INFRASTRUCTURE DESIGN MANUAL

PUBLIC CONSULTATION REPORT

example 1.2

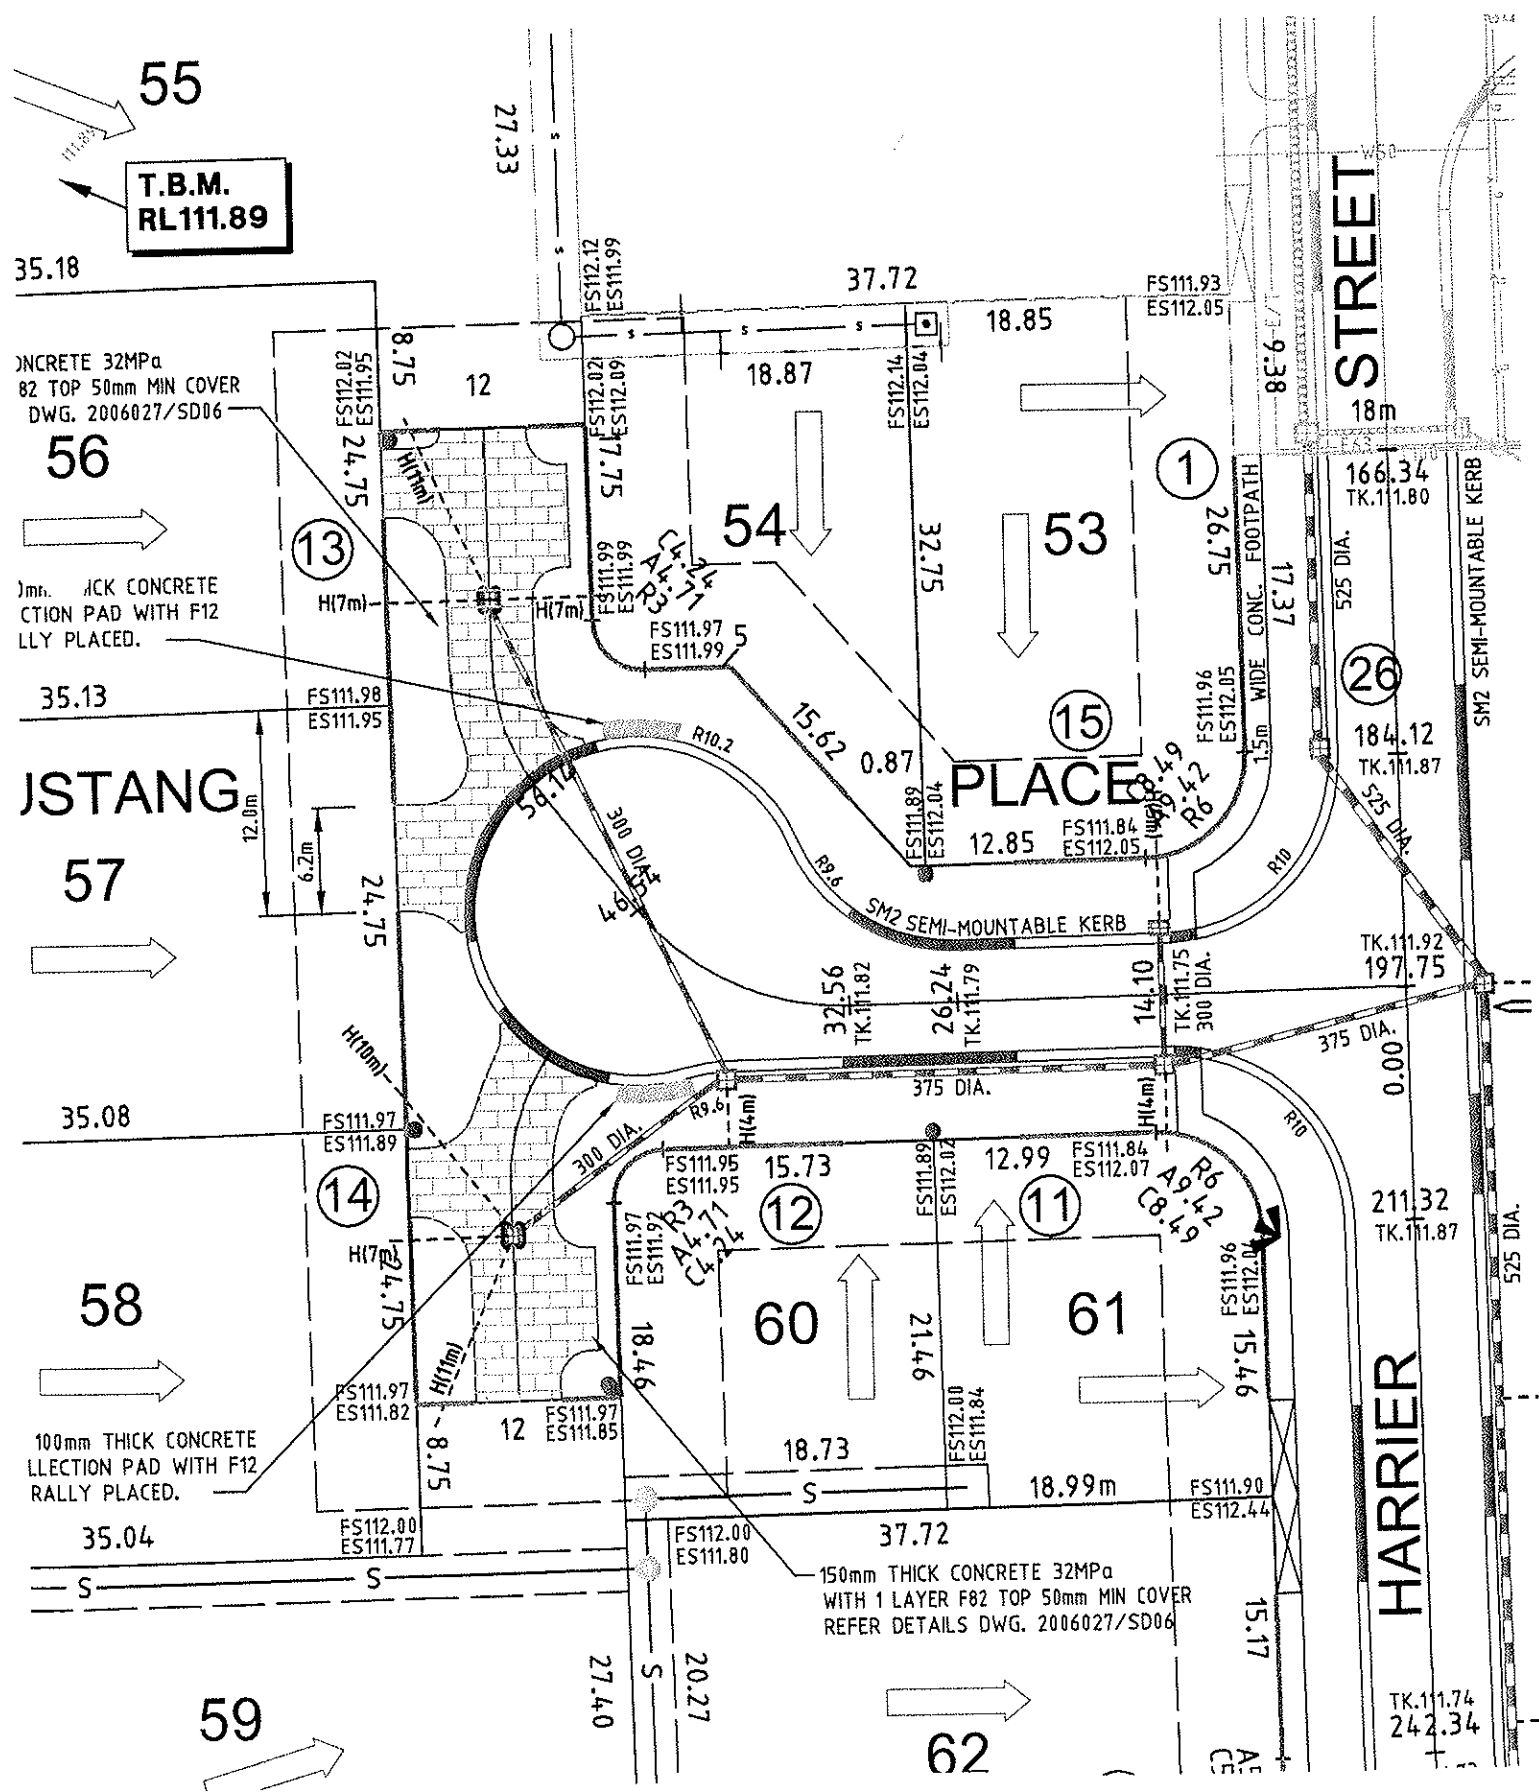
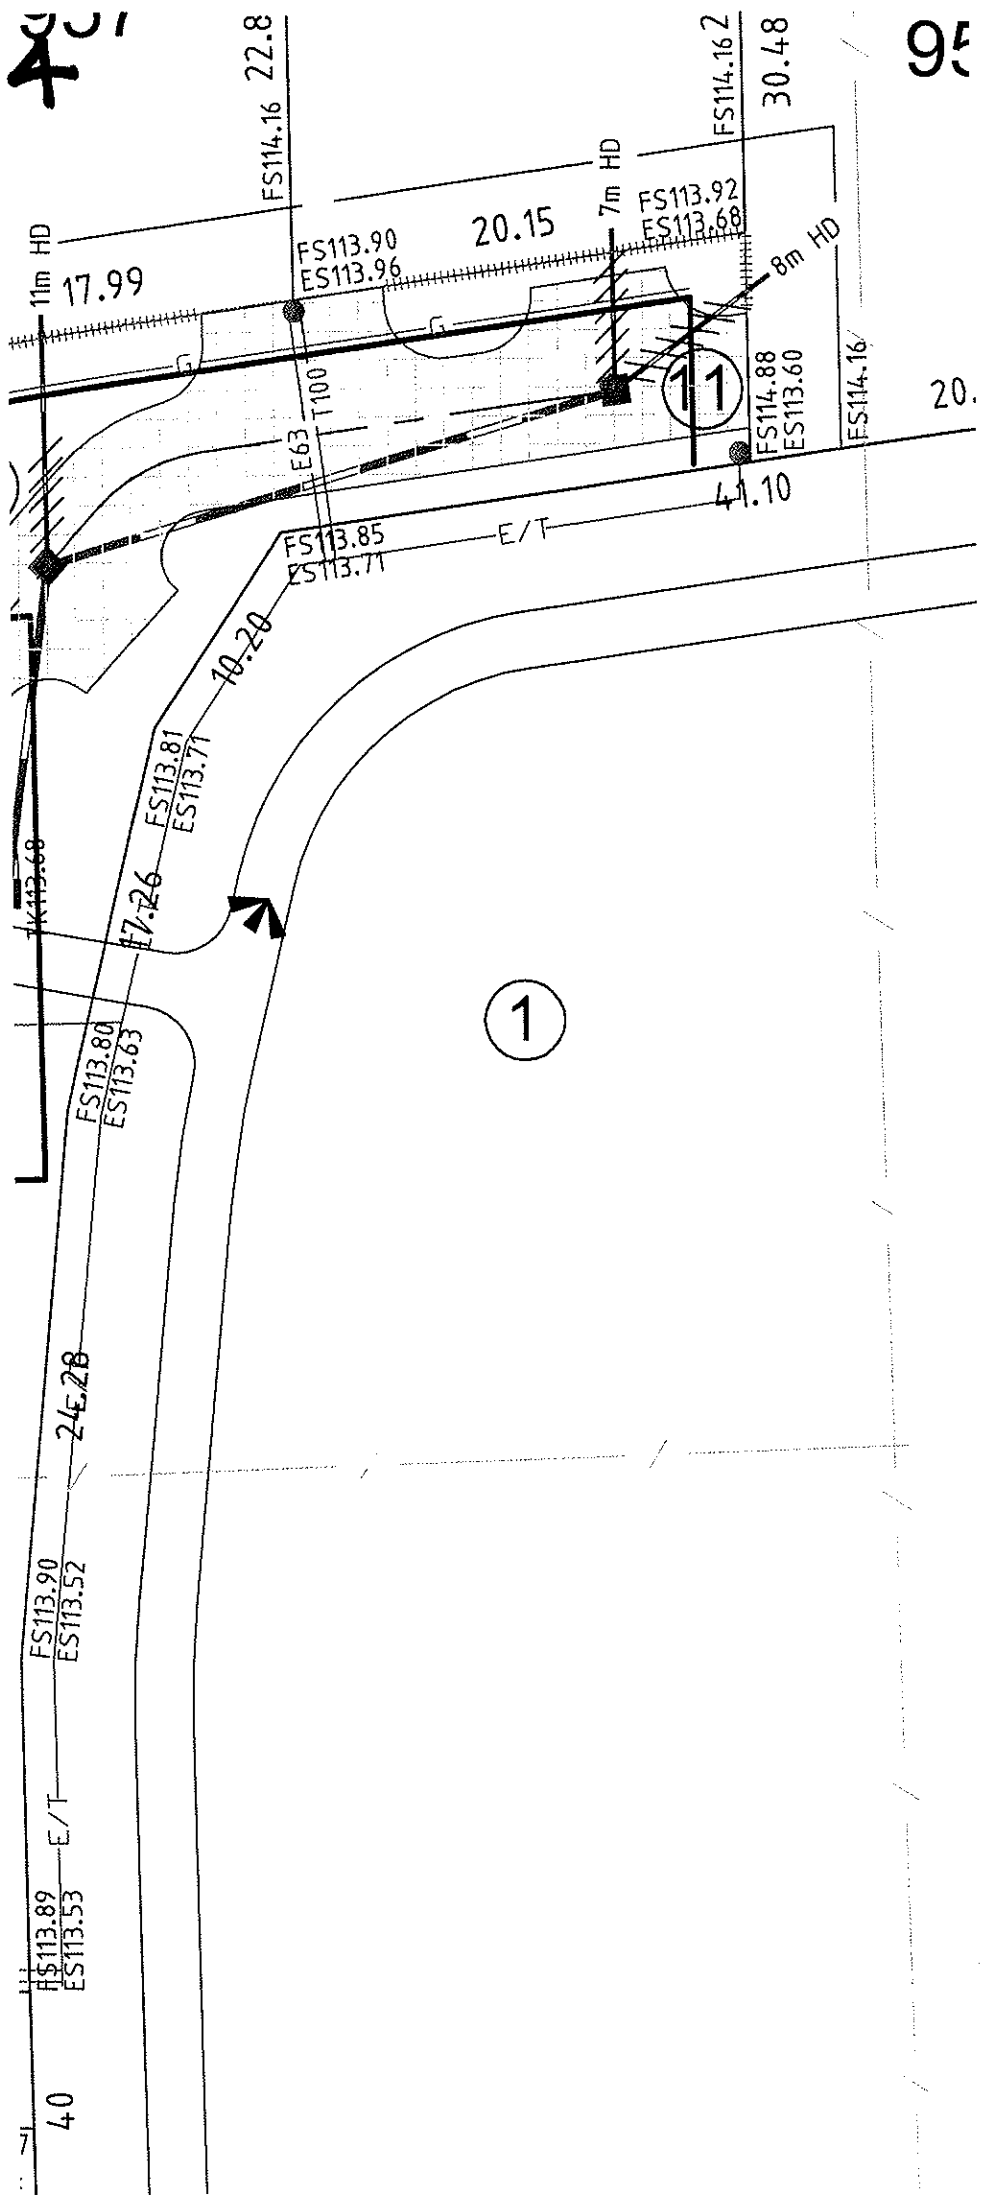
4.	Outline Development Plans	Requirements	4.3	15 th dot point	Cul-de-sacs shall be shown with court bowl ends. Hammerhead or T heads are not permitted. Does this apply to nooks? Where there is insufficient area of land available to provide a court bowl with a turning circle, a short nook which provides a shared driveway style design enables access to two or three allotments. Garbage pads are then provided on the through road at the intersection of the nook so that garbage trucks do not have to enter the nook. Refer to examples 1.1 – 1.4 provided of recently constructed local subdivisions.
